Land at Climping, West Sussex

Transport Statement

i-Transport Ref: TW/BB/ITB16079-002D

Date: 22 March 2022

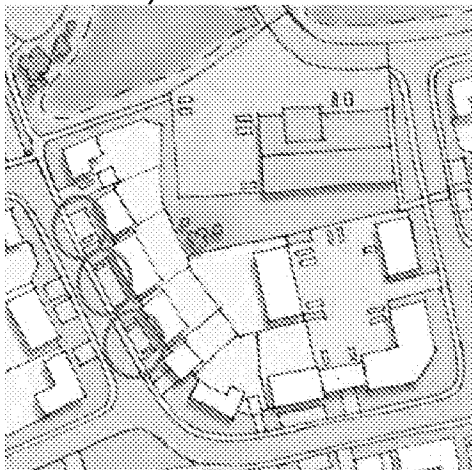
- *It should be confirmed if the road highlighted below has at least one footway abutting the carriageway unless there is a specific planning requirement/feature which requires a verge between the carriageway and footway.*

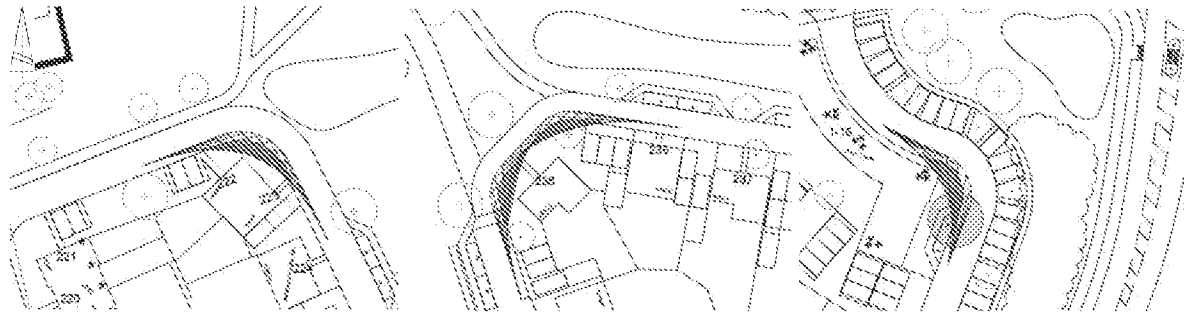
DESIGN ORGANISATION RESPONSE provided by i-Transport on the 15 th March 2022 following formal issue of this Stage 1 Road Safety Audit on the 14 th March 2022	
Agreed -- a covenant will be placed on the affected properties requiring that any planting must be maintained below 600m to ensure the visibility envelopes can be achieved.	
AUDITOR'S VIEW OF DESIGN ORGANISATION RESPONSE dated 15th March 2022	
Confirmation that visibility will be maintained clear of obstructions, addresses the road safety concern at this stage.	
A.2	GENERAL
	No Road Safety Concerns in GENERAL have been raised at this stage
A.3	JUNCTIONS
A.3.1	PROBLEM
Location:	Scheme
Summary:	Visibility extends across land outside the proposed highway
Acc Type:	Vehicle side impact collisions
The proposals associated with this Stage 1 Road Safety Audit, includes general carriageways with footways as well as shared surface areas that are to be provided within a residential development of 300 dwellings that each accommodate off-street parking, be it within driveways or parking courts. The scheme drawings provided with the Audit Brief, illustrate that 25 metre visibility splays are achievable where carriageways meet in accordance with the stopping sight distance of approaching vehicles travelling at 20mph. The presence of speed control bends and traffic calming measures in the form of raised tables and shared surface areas should ensure vehicular speeds are maintained low and that the achievable visibility is adequate. However, the visibility splays illustrated at many of the driveways and entrances to the parking courts, to include in proximity to the local shops and nursery, pass over land that is assumed to be outside the public highway. Should vegetation be planted and permitted to grow within the areas, visibility to and from approaching vehicles could be limited which may lead to a vehicle attempting to exit a priority access when it is not safe to do so, into the path of an oncoming vehicle and lead to side impact collisions.

RECOMMENDATION:	
It is recommended that a sufficient level of visibility is achievable at all times	
Location Plan: (NB: The image below highlights three locations where this item is relevant, more are be present)

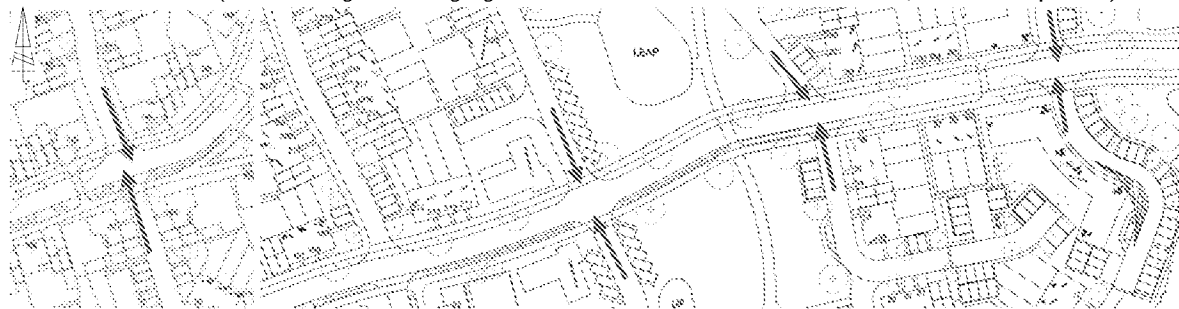
DESIGN ORGANISATION RESPONSE provided by i-Transport on the 15 th March 2022 following formal issue of this Stage 1 Road Safety Audit on the 14 th March 2022	
Agreed – A covenant will be placed on the affected properties requiring that any planting must be maintained to 600mm or below to ensure that visibility splays can be achieved.	
AUDITOR'S VIEW OF DESIGN ORGANISATION RESPONSE dated 15th March 2022	
Confirmation that visibility will be maintained clear of obstructions, addresses the road safety concern at this stage.	
A.3.2	PROBLEM
Location:	Scheme
Summary:	Priority may not be clear to drivers approaching junctions
Acc Type:	Vehicle side impact collisions
The proposals associated with this Stage 1 Road Safety Audit, includes general carriageways with footways as well as shared surface areas with a number of crossroad junctions generated. Vehicular speeds are expected to be low and priorities should be clear where surface treatments change, however, no such details have been provided at this stage and drivers will be able to see through the junction. There are concerns that traffic may approach the primary roads at inappropriate speeds and overshoot into the path of oncoming traffic or fail to give-way leading to side impact collisions

RECOMMENDATION:	
It is recommended that the point at which traffic must give-way is clear	
Location Plan: (NB: The image below highlights two locations where this item is relevant, more are to be present) 	
DESIGN ORGANISATION RESPONSE provided by i-Transport on the 15 th March 2022 following formal issue of this Stage 1 Road Safety Audit on the 14 th March 2022	
Agreed – Road markings will be provided at priority junctions with the primary roads and at the entrance to / exit from the parking facility associated with the proposed local shops.	
AUDITOR'S VIEW OF DESIGN ORGANISATION RESPONSE dated 15th March 2022	
Confirmation that road markings will be provided where appropriate, addresses the road safety concern at this stage.

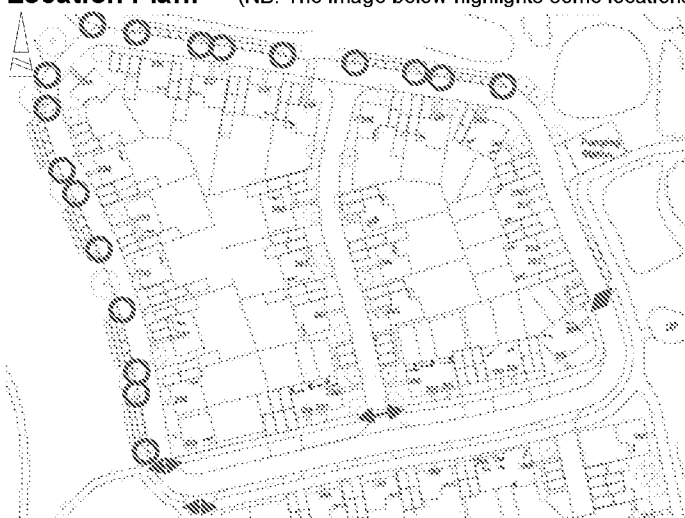
A.4.2	PROBLEM
Location:	Scheme
Summary:	Full height kerbs will be an obstruction to non-motorised users
Acc Type:	Trip / fall and personal injury, vehicle pedestrian collisions
The scheme drawing provided with the Audit Brief, identifies that the proposed development is to consist of general carriageways with footways as well as raised shared surface areas with direct accesses to pathways to properties and footpath / cyclepath links. At this stage no details have been provided to identify the proposed edge treatment around the shared surface areas. Kerbing in excess of 6mm is a trip hazard for pedestrians, those with perambulators, the mobility impaired and cyclists which could lead to falls and personal injury. Further, visually impaired pedestrians could enter a live carriageway into the path of a vehicle unaware leading to a vehicle pedestrian collision	
RECOMMENDATION:	
It is recommended that level access is provided with tactile paving where appropriate along non-motorised user desire lines.

Location Plan: (NB: The image below highlights some locations where this item is relevant, more are present) 	
DESIGN ORGANISATION RESPONSE provided by I-Transport on the 15th March 2022 following formal issue of this Stage 1 Road Safety Audit on the 14th March 2022	
Agreed - Desire lines will be assessed during the detail design of the scheme with dropped kerbs and tactile paving provided where necessary.	
AUDITOR'S VIEW OF DESIGN ORGANISATION RESPONSE dated 15th March 2022	
Confirmation that dropped kerbs and tactile paving will be provided, addresses the road safety concern raised at this stage.

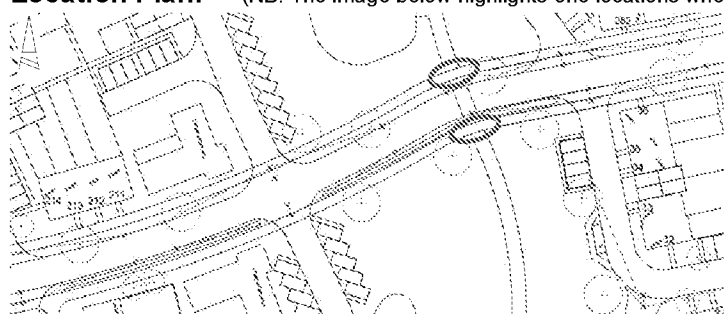
A.4.3	PROBLEM
Location:	Southern side of primary spine road
Summary:	No warning is provided to highlight the change in characteristics of the footways
Acc Type:	Vehicle pedestrian collisions
The proposals include the provision of numerous footways as well as shared surface areas and footpaths / cyclepaths through the open space within the application site. The Audit Team have concerns that pedestrians travelling from a footway will step onto a shared area without warning that cyclists or vehicular traffic could be present. A pedestrian not becoming aware that they are entering a shared area where cyclists or motorists could be present, may step into their path leading to a vehicle / cyclist collision with a pedestrian.	
RECOMMENDATION:	
It is recommended that corduroy / hazard warning tactile paving is provided where the characteristics of the surface change	
Location Plan: (NB: The image below highlights one locations where this item is relevant, more are present)

DESIGN ORGANISATION RESPONSE provided by I-Transport on the 15th March 2022 following formal issue of this Stage 1 Road Safety Audit on the 14th March 2022	
Agreed -- Corduroy paving will be provided where necessary, this will be dealt with at the detailed design stage.	
AUDITOR'S VIEW OF DESIGN ORGANISATION RESPONSE dated 15th March 2022	
Confirmation that tactile paving will be provided where appropriate, addresses the road safety concern raised at this stage.	
A.4.4	PROBLEM
Location:	Southern side of primary spine road
Summary:	Hedges could grow to limit visibility to and from a non-motorised user
Acc Type:	Vehicle pedestrian collisions
The proposals include the provision of numerous footpaths / cyclepaths through the proposed development area as well as footways besides the proposed on-site carriageways. The site layout plan provided with the Audit Brief, illustrates what is believed to be hedges to the south of the primary spine road and either side of where the proposed footpaths meet the carriageway. No landscaping details have been provided at this stage. Should the planting be permitted to grow higher than 600mm there is a risk that insufficient intervisibility will be available. Recent updates

to the Highway Code have introduced pedestrian and cyclist priorities over vehicular traffic and therefore drivers are required to stop and to allow non-motorised users to cross side roads, however, limited visibility could result to the users not becoming aware of one another at a safe distance leading to vehicle non-motorised user collisions	
RECOMMENDATION:	
It is recommended that no foliage is planted within pedestrian visibility slays to ensure clear visibility is maintained at all times	
Location Plan: (NB: The image below highlights two locations where this item is relevant, more are present) 	
DESIGN ORGANISATION RESPONSE provided by I-Transport on the 15 th March 2022 following formal issue of this Stage 1 Road Safety Audit on the 14 th March 2022	
Agreed – this will be dealt with at the detailed design stage.	
AUDITOR'S VIEW OF DESIGN ORGANISATION RESPONSE dated 15th March 2022	
Confirmation that this road safety concern will be further considered during the detail design of the scheme, addresses the road safety concern raised at this stage.
